I'm Hal Jaeger, and I serve on the Neighbourhood Association Heritage and Development Committee. I would like to thank Activa for reaching out to the neighbours so generously. There is much to be admired in the proposed build: the handsome design, the selected materials, the care for the contiguous neighbours along Ellen St.

The analysis of how the proposal conforms to the Heritage District Plan, which I will abbreviate to HDP, as defined by the Terms of Reference, is simplified because the HDP includes Site Specific Policies – requirements – for 30-40 Margaret, as opposed to general, district-wide guidelines that might require interpretation. The HDP also includes Site Specific Guidelines which I believe deserve extra regard, because they come under the umbrella of Site Specific Policy h) which states:

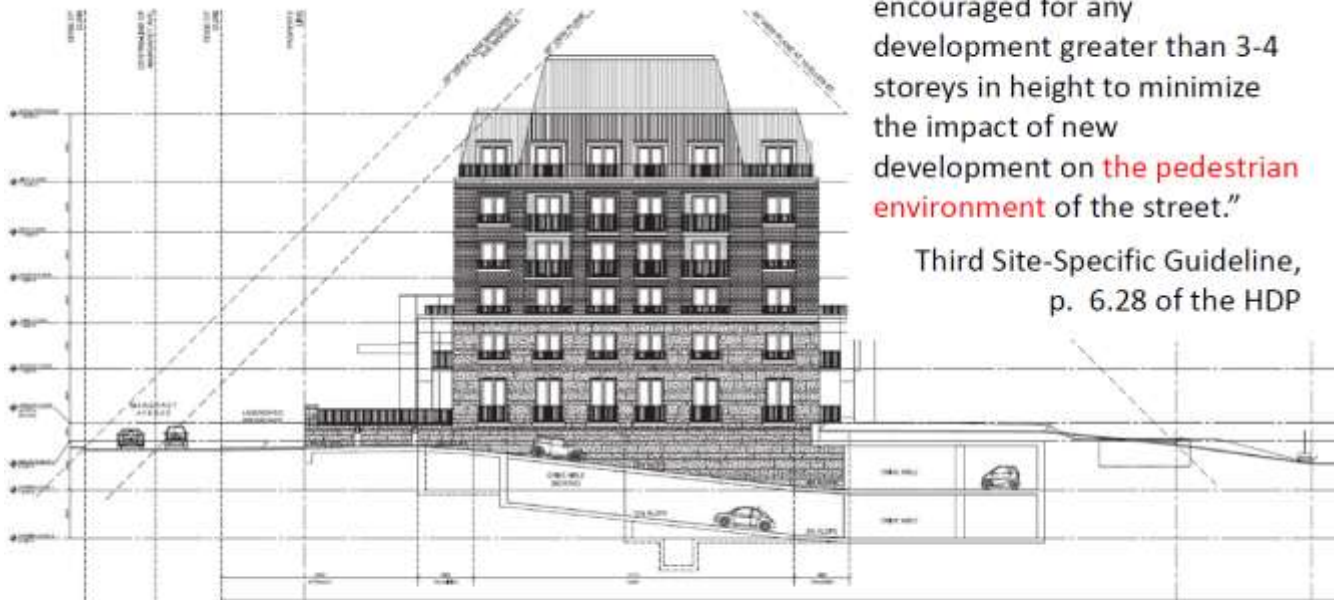
Following the official definition, the top of a porch does not constitute a stepback, and the façades of the two proposed buildings extend without a stepback from the ground floor to the top of the fifth floor.

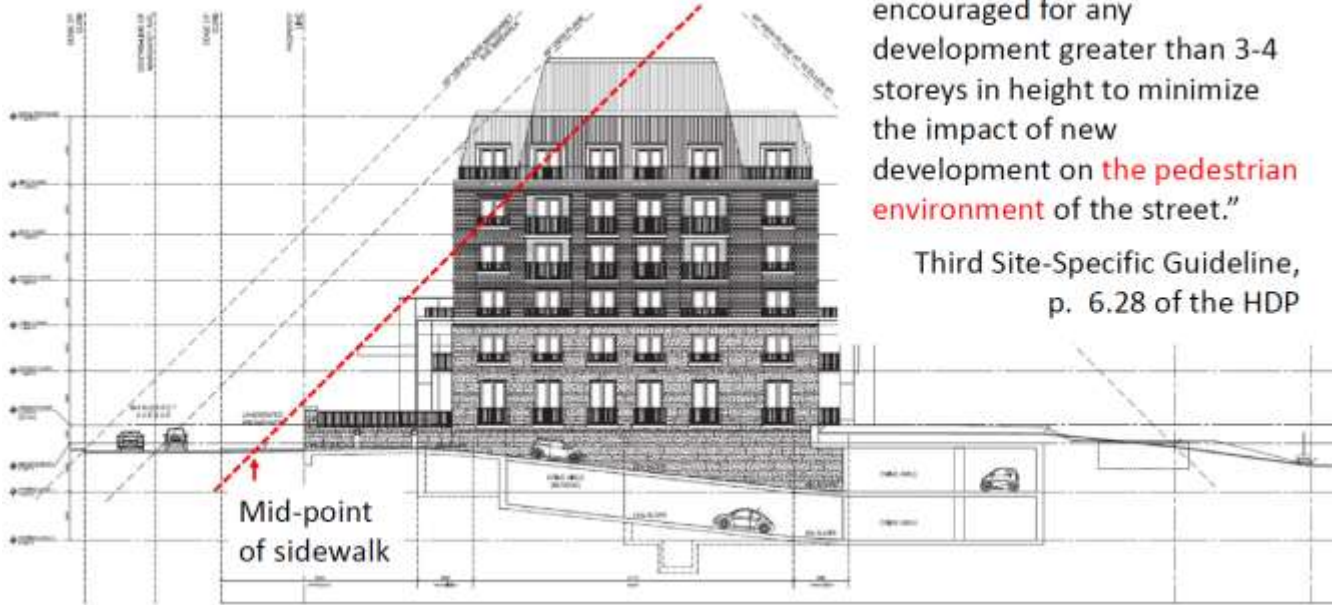
As to the HIA’s angular planes analysis, one plane starts at the curb edge on the south side of Margaret. The other at the centreline of the street. But the third Site-Specific Guideline states “Building setbacks are encouraged for any development greater than 3-4 storeys in height to minimize the impact of new development on the pedestrian environment of the street.”

I’ve added the red angular plane originating at the centre of the pedestrian environment, the sidewalk. This angular plane makes contact with the façade of the proposed building just below the top of the fourth floor. Moreover, as was stated previously, the guideline does not refer to angular planes in assessing conformity with the policies. The guideline calls for setbacks, multiple setbacks.

Site sections through proposed infill development on Margaret Avenue. Note 15m rear yard setback, 3 storey height at street and maximum 5 storey height mid block. Step back at 45 degrees above third floor.

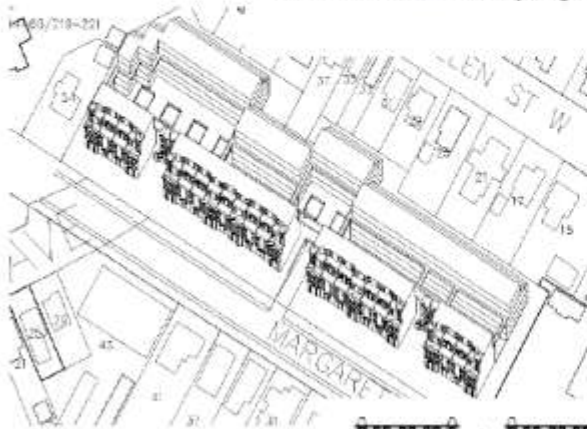
The illustrations that follow the site-specific guidelines show one mode of adhering to the HDP.

We see stepbacks at 45 degrees above the third floor which permit light into the neighbourhood and minimize the perceived height difference between the 5 storey building and the two to two and a half-storey neighbours.

We see the stepback line up with the eaves of the depicted neighbourhood house.
